**AGENDA  
CITY OF CEDAR FALLS, IOWA  
PLANNING AND ZONING COMMISSION MEETING  
WEDNESDAY, MARCH 11, 2020  
5:30 PM AT CITY HALL**

**TO:** Planning and Zoning Commission  
**FROM:** David Sturch, Planner III  
**DATE:** March 4, 2020  
**SUBJECT:** Site Plan Review: 312 W. 1<sup>st</sup> Street

**TO:** Planning and Zoning Commission  
**FROM:** David Sturch, Planner III  
**DATE:** March 4, 2020  
**SUBJECT:** Community Bank and Trust Easement Vacation

**TO:** Planning & Zoning Commission  
**FROM:** Stephanie Houk Sheetz, Director of Community Development  
**DATE:** March 4, 2020  
**SUBJECT:** Site Plan Review for the Plaza at River Place Properties

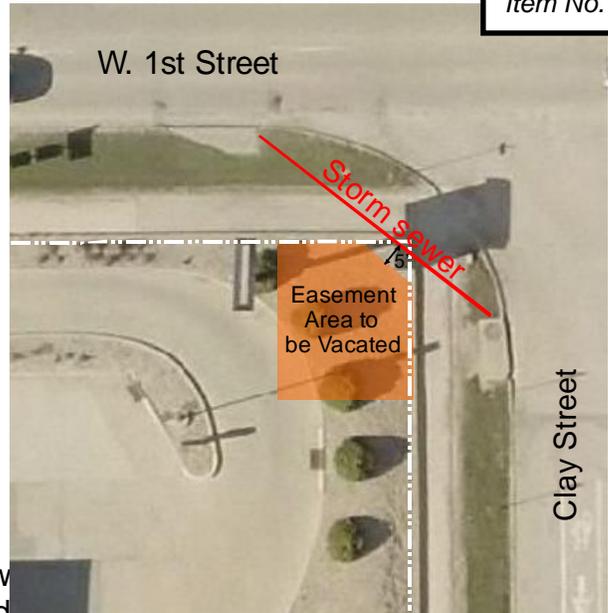
This request is to vacate a portion of a 19.2' by 21.9' storm sewer easement located at the northeast corner of the property at 312 W. 1<sup>st</sup> Street. This easement area is approximately 420.5 square feet. It is proposed to retain a 50 square foot area off the northeast corner and vacate the remaining 370.5 square feet for the construction of a new bank facility.

The steps that lead up to the plaza space from the street corner will need to be chamfered (cut at a diagonal) to keep them out of the easement. It should be noted that the canopy will still extend over the easement, but is located at a height that will likely to provide adequate space if any work would ever have to be done to the storm sewer. In the unlikely event that the canopy was damaged while work was being done in the easement, the bank or any other future owner of the building will be responsible for the cost of repairing it.

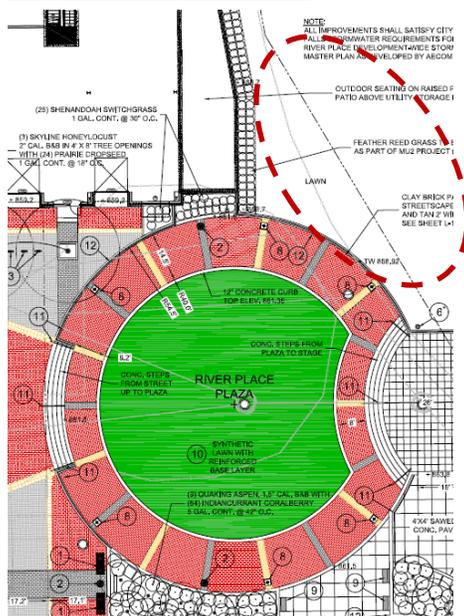
The style of lighting is another point of review. Below, staff provides a highlighted version of the site plan, enabling a quick review of the lighting types and locations. The decorative light matching the streetscape (Lumec Serenade) would be along the street and up the stairs on the east side of the Plaza. The bollards are proposed along the area south of the Plaza (along the trails heading east connecting to the levee trail). The style of bollards proposed match those found in the back areas of the River Place development. Theatrical lights are within the Plaza. Outside of planned events, it is anticipated they will provide some lighting for the area until approximately 10 p.m. The brightness and timing will be monitored and adjusted as needed.

The intent has been that the Plaza complements the downtown streetscaping. Staff feels the changes proposed accomplish this. Streetscape lights are used in the focal areas, while different lighting is to the south side of the site, providing continuity with the River Place development. Theatrical lights remain consistent in their use and general location from 2016 to 2020. The poles are simple 6" round poles, to be painted black.

**2020 Proposed Plan**

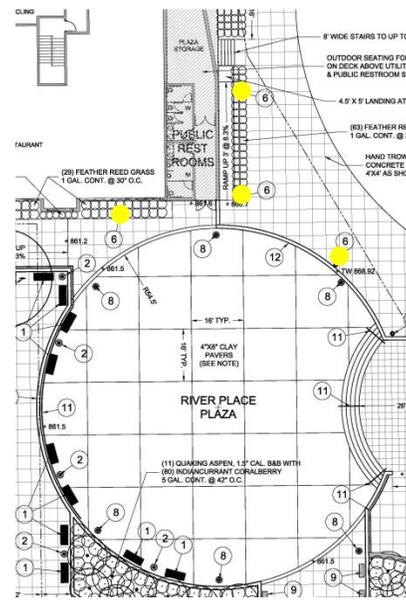
Area lighting has been removed on the north side of the Plaza, circled in red on the 2020 plan below. Originally, the developer anticipated steps from the residential area (in the MU2 building) to a gathering area on the north side of the Plaza. This area was also going to be generally level with the levee and feature concrete walking/gathering area. This is no longer planned due to several factors. This area is now proposed for seeding and landscaping. The public and residents will not be encouraged to heavily use this area; therefore ambient lighting from the Plaza will be sufficient. The Developer also plans to add landscaping along the north wall of the Plaza, which will add decorative features while discouraging heavy use of that area.

A decorative light has been removed from the street edge, near the staircase from the sidewalk to Plaza. This seems appropriate for several reasons: it removes visual barriers to the Plaza, removes a conflict with the brick pattern for this area, and improves spacing of lighting given a double head light is on the north side of E 2<sup>nd</sup> St. Staff requested a double head light be located at the southeast corner of the State Street/2<sup>nd</sup> St. intersection, to complement the pattern of double-head lights found at most downtown intersections. The Developer is updating the plans to make that change.

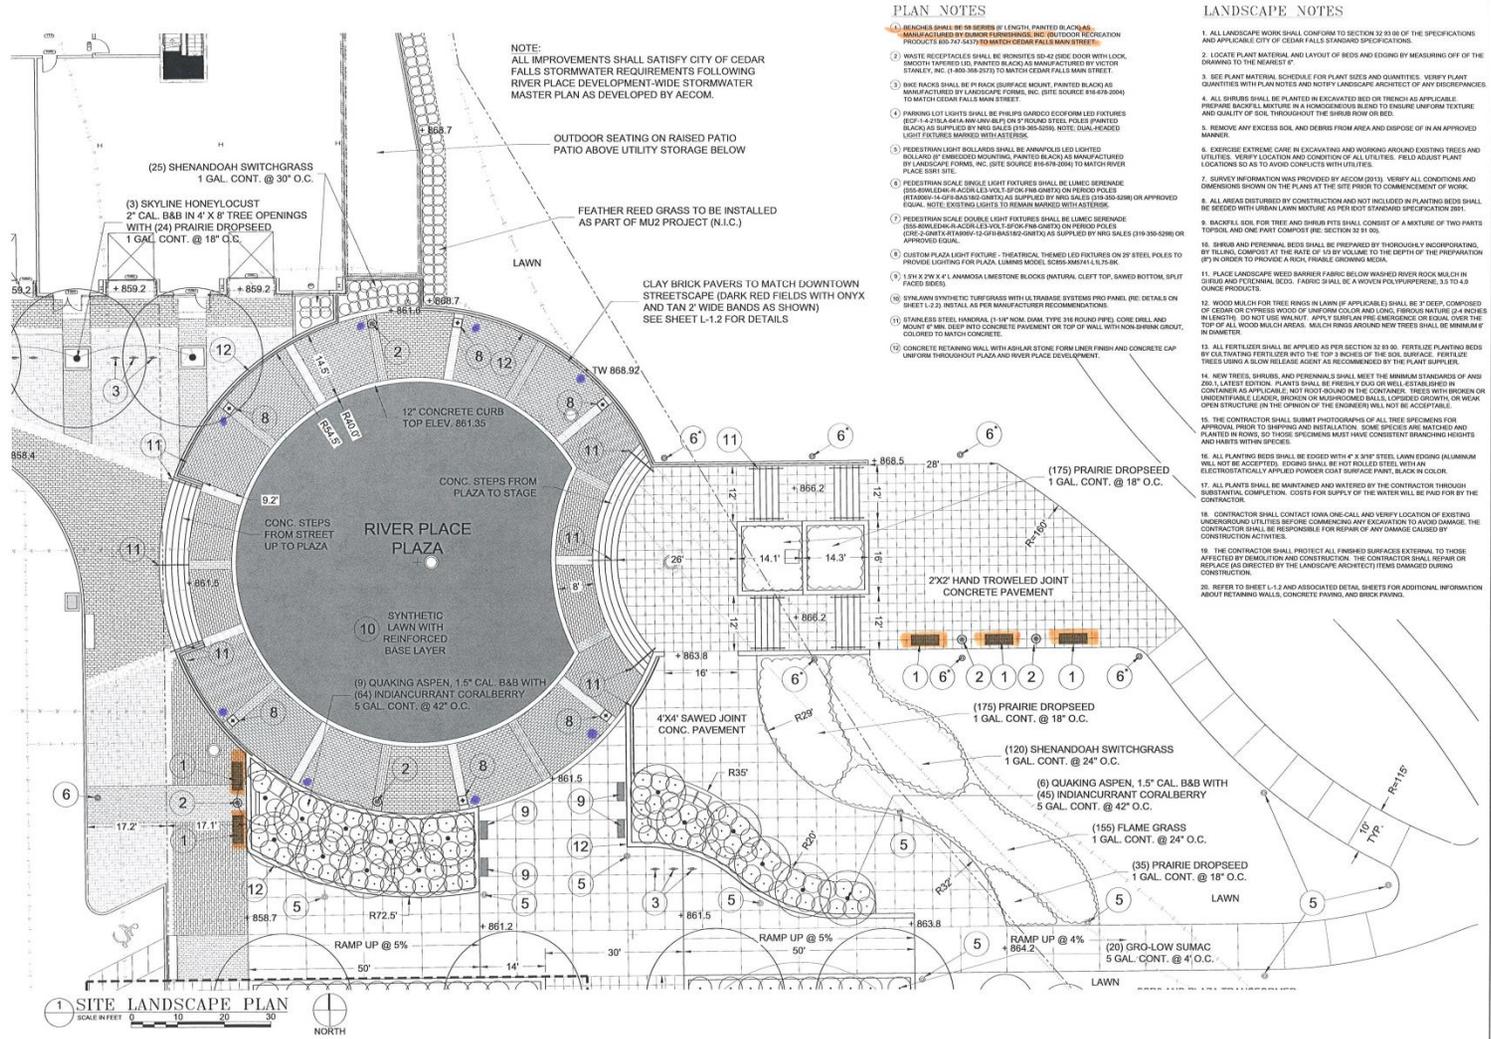
The 2016 site plan shows 13 black benches by Dumor, matching the downtown benches. It is proposed that a movable table/chair combination be placed within the Plaza. This seems reasonable. A table/chair offering would encourage lunches and meetings, contributing to the Plaza's ambiance. The stairs connecting the public sidewalk to the Plaza drives re-locating or removing several benches. However, the same total quantity is proposed: 8 table/bench combinations and 5 benches. The following pages provide comparison drawings from 2016 site plan to the proposed plan.

The developer has agreed to move one bench at the top of the stairs from the south side to the north side. This would better balance the benches found on the south side in that location.

**Staff recommends approval of the changes.**

**2020 Proposal:**

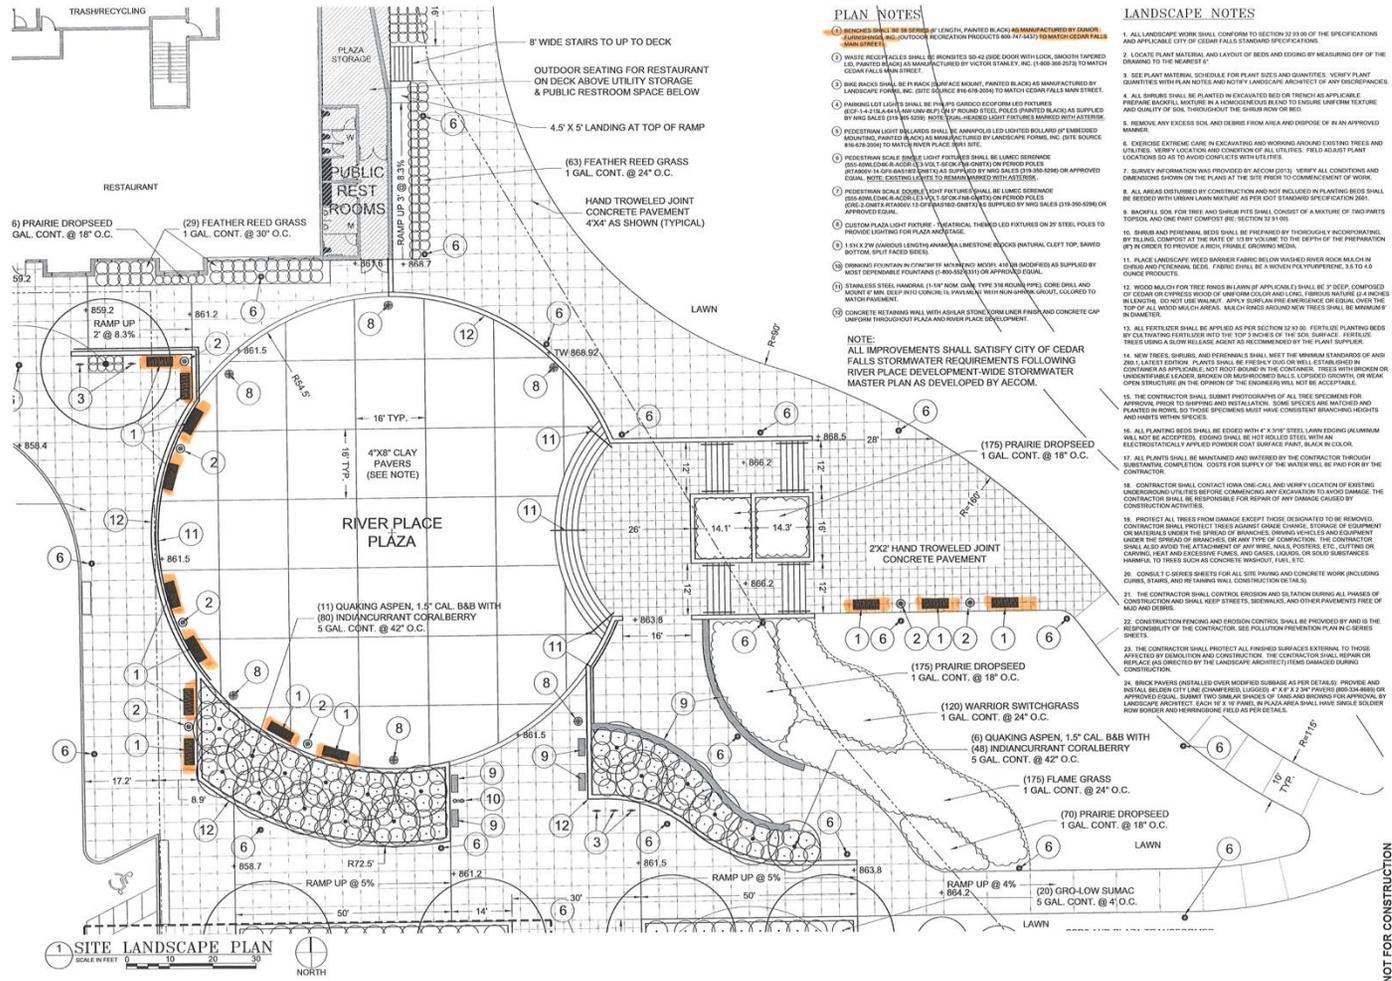
The 2016 site plan included seven trash receptacles, partnered with bench locations. The current plan includes five. The Plaza area includes two trash cans. The change is not substantial and is related to the change in bench locations.
